BID NO. 13-04

SUBJECT: 6th Floor Office Renovation/ Arlington High School

ADDENDUM NO. 6

**6TH FLOOR OFFICE RENOVATION
ARLINTON HIGH SCHOOL**

REF. DRAWING NO. 1

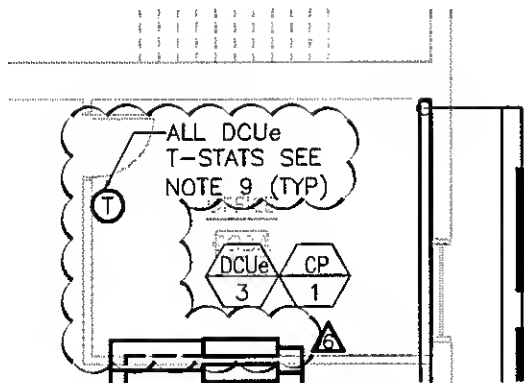
SELECTION BASED ON "MITSUBISHI", PROVIDE WIRELESS TSTAT, LOW AMBIENT CONTROL AND INTERNAL MOUNTED CONDENSATE PUMP OF MODEL LISTED ABOVE. CPM BASED ON FANS SET AT LOW SPEED. PROVIDE WITH AIR COOLED CONDENSING UNIT AS INDICATED IN THE SCHEDULE. ALL REFRIGERANT TUBING SHALL BE SIZED BY UNIT MANUFACTURER. PROVIDE ALL NECESSARY JOINT KITS, FITTINGS AND ACCESSORIES FOR A COMPLETE OPERATING SYSTEM PER MANUFACTURER'S RECOMMENDATIONS. PROVIDE NECESSARY EQUIPMENT FOR FUTURE BMS SYSTEM INTERFACE. COORDINATE CONTROL PROTOCOL REQUIREMENTS WITH ATC CONTRACTOR SYSTEM SHALL BE CAPABLE OF HEATING OR COOLING SYSTEM CHANGEOVER.

IF ALTERNATE NUMBER 2 IS ACCEPTED FOR THE PROJECT THE CONTRACTOR SHALL PROVIDE THIS EQUIPMENT AND PLACE ON ROOF. CONTRACTOR TO COORDINATE LOCATION ON ROOF WITH OWNER. UNIT SHALL BE MOUNTED ON 4x4 FT SLEEPERS IN ACCORDANCE WITH THE MANUFACTURER'S RECOMMENDATIONS. OWNER SHALL BE RESPONSIBLE FOR CONNECTING EQUIPMENT INTO EXISTING SYSTEM.
